**SERVICE BULLETIN**

**APPLICABILITY:** 2012-16MY Impreza 4-Door  
2015-20MY WRX and STI

**NUMBER:** 12-301-20  
**DATE:** 10/20/2020

**SUBJECT:** Rattling Sound from Rear Package Shelf Area

**Dislocated Cushions**

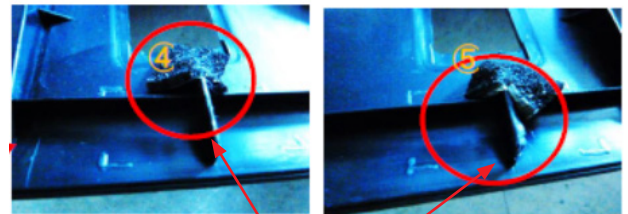
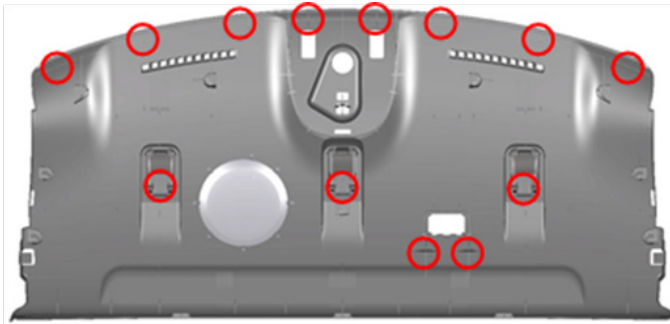
A higher durability material will be used for the cushions placed at the red circles below.

Foam Sheet (**66099AG110**)

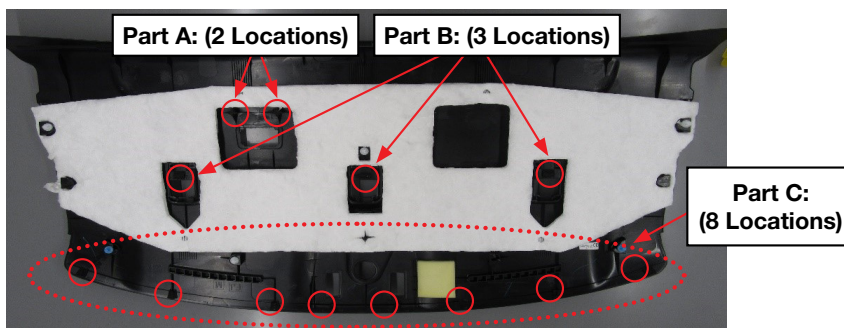
- Prepare the self-adhesive foam sheet p.n. **66099AG110** containing pre-cut sections (cushions) 20mm x 20mm (0.79 in x 0.79 in).

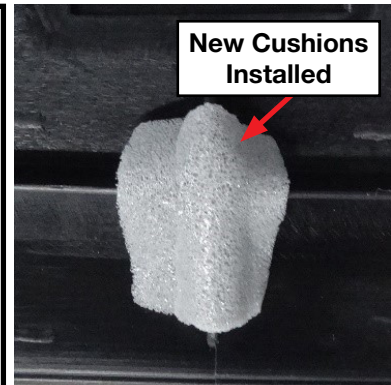
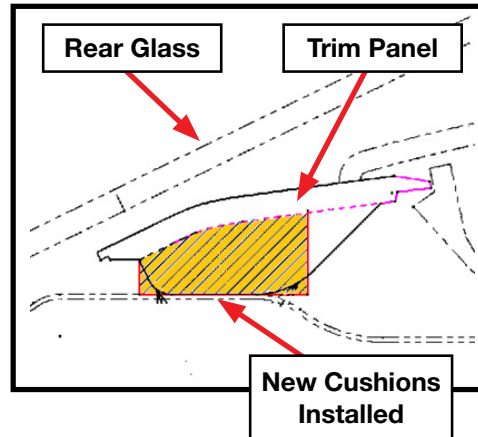
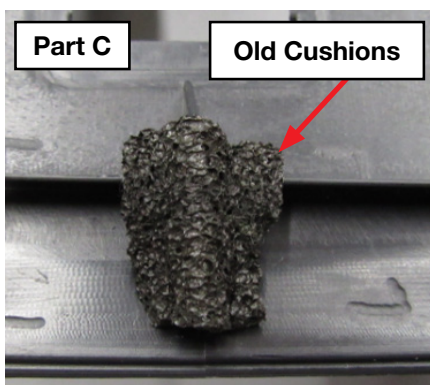
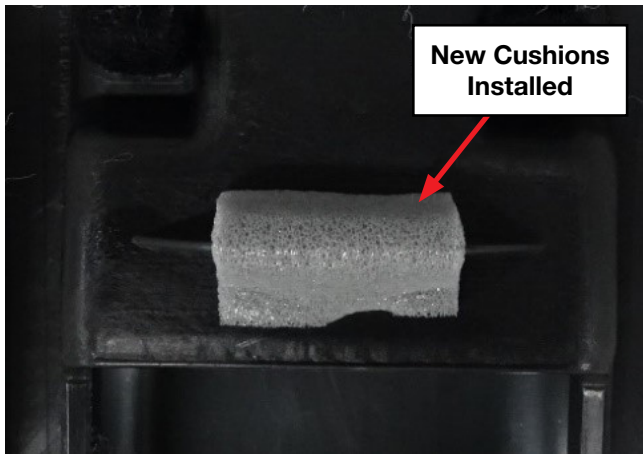
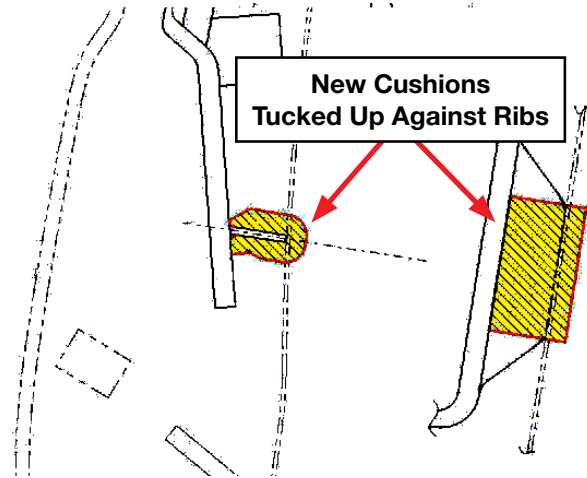
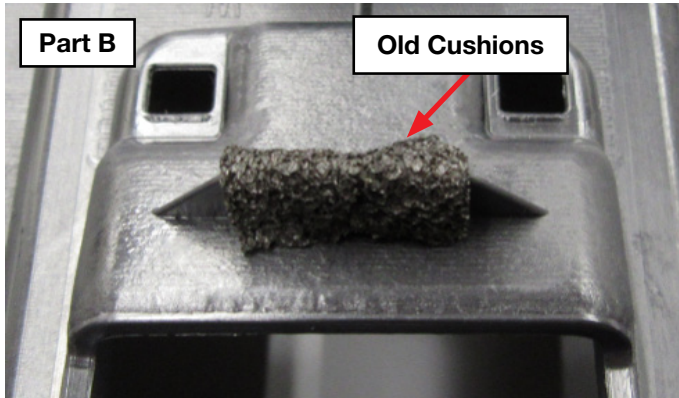
- Remove the TRIM PANEL ASSEMBLY-REAR SHELF following the procedure in the applicable Service Manual.
- Remove the old cushions. There is a total of 13 cushion locations: **Part A:** 2 locations, **Part B:** 3 locations and **Part C:** 8 locations.
- Always remove any residue left behind then adhere the new cushions at each of the 13 locations as shown below. The new cushions cover the tip of the ribs firmly in **Parts A & B**. For **Part C**, the cushion should cover the whole rib.
